OUTBOARD PLAN
(TOPSIDE VIEW)

MAXIMUM DIMENSIONS	24-9-BB-001-001	24-9-BB-001-001	H
0001-001-001	SCALE 1/8"=1'-0"	PAGE 02 FT.SHEET 2 of 7

240-WLBB-601-001 2 H

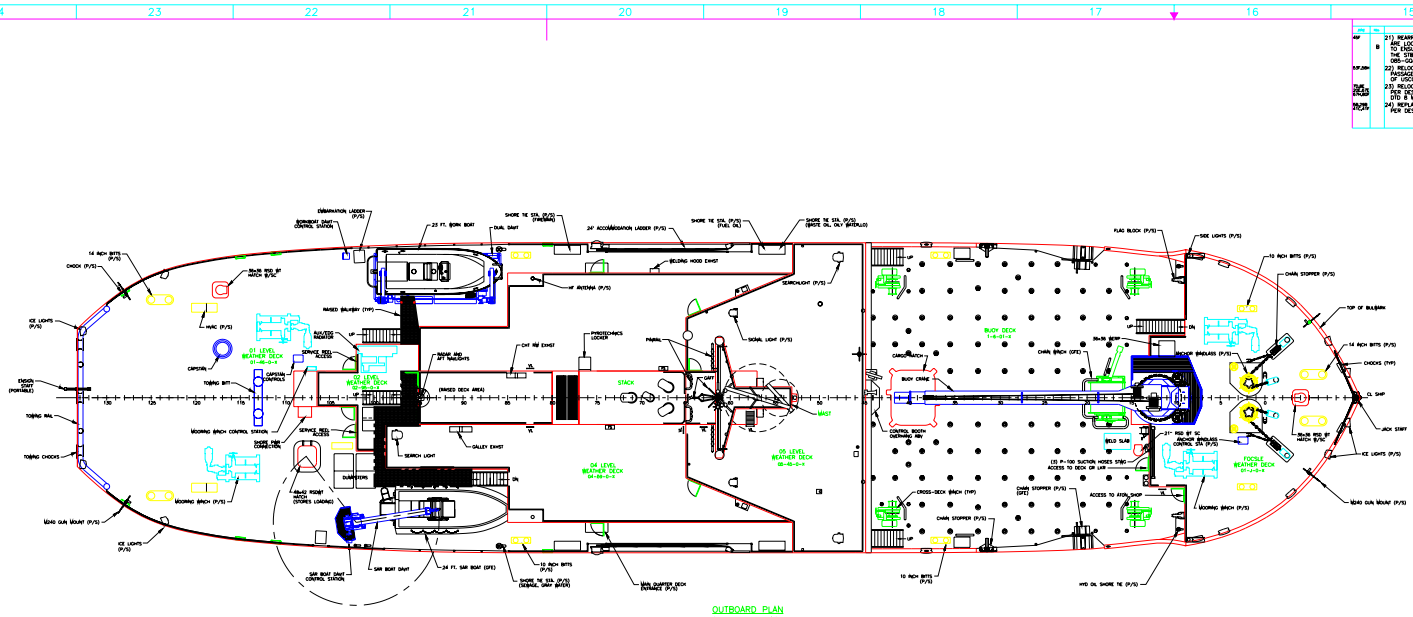
REVISIONS			
STAT	SYM	DESCRIPTION	DATE
	A	20) RELOCATED SHORE TIE STATIONS (P/S) FR.84 AFT TO DECK EDGE AT FR.116 (P/S) TO OPEN UP PASSAGE AROUND DECK HOUSE. THIS WILL NOT CONTAMINATE OTHER EQPT ON THE STBD SIDE PER DESIGN CONCERN 1 OF USCG LTR SER 085-GQA-0056 DTD 8 MAR 02.

21) REMOVED SMALL STACK AT FR.93 (PORT) FOR AUX/EMER GENERATOR EXHAUST.	
		22) CHANGED BRIDGE DECKHOUSE STRUCTURE INCORPORATING CHAMFERED CORNERS AND SLOPING AFT BHDS TO IMPROVE VISIBILITY.

23) DELETED AFFT HOSE REELS THROUGHOUT VESSEL PENDING DESIGN DEVELOPMENT.	
		24) MOVED LUBE OIL TANKS INTO AMR FR.54-57 & CHANGED SIZE TO 1040 GAL. EACH.

25) RELOCATED MINOR MACHINERY & PUMPS IN MACHINERY SPACES TO SUIT DESIGN DEVELOPMENT.	
		26) DELETED BUILT-IN HYDR OIL TK 2-5-0-U AND ADDED A 1160 GAL. INDEPENDENT TANK IN HYD MCHRY RM NO.1.

27) RENAMED SEVERAL COMPARTMENTS TO AGREE WITH COMPT. NOS. & DESIGNATORS TO SUIT DESIGN DEVELOPMENT. (HYD MCHRY RM, TROP RANGE/MAIN RM, SERE MCHRY RM, 2-5-1 HYD PUMP RM AND POTB MCHRY RM). CHANGED COMPT NOS & DESIGNATORS TO SUIT DESIGN DEVELOPMENT.

28) CHANGED DESIGN WATERLINE TO 15'-6" TO REFLECT ATON FULL LOAD AT DELIVERY.	01/22/02 FJHOHLEN
	B	1) INDICATED AREAS ALLOCATED FOR LOUNGE IN THE CPO MESS AND WARDROOM TO DEMONSTRATE COMPLIANCE, PER CONTRACT COMPLIANCE COMMENT 1 OF USCG LTR SER 085-GQA-0056 DTD 8 MAR 02.

2) DELETED CLEANVIEW SCREENS AT F & S COMMND STATIONS, RETAINED CENTERLINE SCREEN DUE TO DRY WATCH I REQMT. PER COMPLIANCE COMMENT 3 OF USCG LTR SER 085-GQA-0056 DTD 8 MAR 02.

3) ALTERED BLACK WATER TANK TO MAKE ADJUSTMENT FROM STRUCTURE AND ADDED TO MEET REQUIRED VOLUME PER COMPLIANCE COMMENT # OF USCG LTR SER 085-GQA-0056 DTD 8 MAR 02.

4) ALTERED GRAY WATER TANK TO ACHIEVE REQUIRED VOLUME AND ADDED FLEXIBILITY, PER COMPLIANCE COMMENT 5 OF USCG LTR SER 085-GQA-0056 DTD 8 MAR 02. WORKING VOLUME WILL BE INDICATED ON AREA/VOL REPORT.

5) CHANGED NUMBERING SEQUENCE FOR THE MAIN GENSETS PER COMPLIANCE COMMENT 6 OF USCG LTR SER 085-GQA-0056 DTD 8 MAR 02.	
		6) MOVED AFT BHD AND SEGREGATING QUARTERDECK STATIONS FROM ENTRANCE/EGRESS PER COMPLIANCE COMMENT 6 OF USCG LTR SER 085-GQA-0056 DTD 8 MAR 02.

7) MOVED BT BHD 34, 6" FWD AND BT BHD 35, 2" FWD TO COMPLY WITH SUBDIVISION REQUIREMENTS. REF. COMPLIANCE COMMENT 9 OF USCG LTR SER 085-GQA-0056 DTD 8 MAR 02.

8) ADDED CCD LWR ON MAIN DECK FR.47 STBD PER CONTRACT COMPLIANCE COMMENT 10 OF USCG LTR SER 085-GQA-0056 DTD 8 MAR 02. ADDED ACCESS TO AFT BOTTLES PER DESIGN DEVELOPMENT. BOTTLES WERE LOCATED IN 01 LEVEL PASSAGE.

9) ADDED A DOUBLE DOOR ACCESS TO THE MCD SPACE PER DESIGN CONCERN 1 OF USCG LTR SER 085-GQA-0056 DTD 8 MAR 02.	
		10) ALTERED DECKHOUSE AND MODIFIED BULKHEADS THROUGHOUT TO ENSURE STRUCTURAL CONTINUITY. MAJOR MODIFICATIONS INCLUDE MOVING THE AUX GEN RM UP TO 02 LEVEL, ADDING A SEPARATE "HOUSE" FOR SERVICE REELS AND MAKING THE CURRY DUCT, MOD AND HATCHWAY ACCESSIBLE. ADDED MAIN LONGITUDINAL AND TRANSVERSE STRUCTURE WHERE POSSIBLE. STANCHIONS WERE ADDED AT FR.57 & 67 FROM 01 LEVEL UP TO THE HOUSE TOP. INNERBOTTOM FLATING PLATE WAS ADDED AT FR.57 & 67 FROM 01 LEVEL UP TO THE HOUSE TOP. (REFERENCE DRAWINGS 2.3.4 & 5 OF USCG LTR SER 085-GQA-0056 DTD 8 MAR 02.

11) RECONFIGURED FUEL TANKS FR.15-36 FOR PRODUCIBILITY. ADDED FUEL TANKS 2-0-0-F, 2-1(2)-1-L, 2-1(2)-2-L. ADDED 2 FUEL TANKS TO ACHIEVE REQUIRED FUEL CAPACITY OR FUEL MEETS CAPACITY REQUIREMENTS. REF DESIGN CONCERN 7 & 8 OF USCG LTR SER 085-GQA-0056 DTD 8 MAR 02.

12) CHANGED SUPPLY DUCTING FROM INTERNAL TO THE HOUSE TO EXTERNAL TO THE HOUSE. ADDED SUPPLY LOUVERS TO 02 LEVEL AND ORIENTED RIGHT DUCTING.	
		13) MOVED GALLEY EXHAUST FROM PORT TO STBD AND ORIENTED EXHAUST AND AWY FROM BOAT PER DESIGN CONCERN 12 OF USCG LTR SER 085-GQA-0056 DTD 8 MAR 02.

14) REORIENTED AFT SURVIVAL SUIT STWG TO FRONT OF SERVICE REEL HOUSE TO PROVIDE MORE ACCESS TO THE BOAT PER DESIGN CONCERN 13 OF USCG LTR SER 085-GQA-0056 DTD 8 MAR 02.

15) REARRANGED MESS DECK AFT OF FR.91, MOVING THE GALLEY AND STORES TO THE STBD SIDE. THIS ARRGT PROVIDES BETTER ACCESSIBILITY AND STRUCTURAL CONTINUITY. ALSO REMOVED ACCESS DOOR TO GALLEY. CHANGED DOOR TO STORES. REMOVED ACCESS TO AFTSIDE "CHOPPER" DECK. REF. DESIGN CONCERN 14 OF USCG LTR SER 085-GQA-0056 DTD 8 MAR 02. MIRRORED ARRANGEMENTS ON FIRST PLATFORM AND INNERBOTTOM TO SUIT MESS DECK CHANGE.

16) MOVED ACCESS DOOR TO THE BARDRM TO OFF MAIN PASS. AND DELETED DISHWASHER PER DESIGN CONCERN 16 OF USCG LTR SER 085-GQA-0056 DTD 8 MAR 02.	
		17) RELOCATED THE ADDITIONAL AFT TO 02 LEVEL AND SEGREGATED FROM ENTRANCE/EGRESS PER DESIGN CONCERN 18 OF USCG LTR SER 085-GQA-0056 DTD 8 MAR 02.

18) RELOCATED THE STORES LOADING HATCH FROM PORT TO STBD AND MADE WEATHER HATCH RAISED PER DESIGN CONCERN 20 OF USCG LTR SER 085-GQA-0056 DTD 8 MAR 02.

19) DELETED SPACE RESERVATION FOR TRASH HOIST BETWEEN 02 AND 03 LEVEL AND ADDED A TRASH HOIST PER CONCERN 21 OF USCG LTR SER 085-GQA-0056 DTD 8 MAR 02.

20) MOVED THE GRAY WATER PUMP OUT OF THE POTB (OFF MM PER DESIGN CONCERN 22 OF USCG LTR SER 085-GQA-0056 DTD 8 MAR 02.
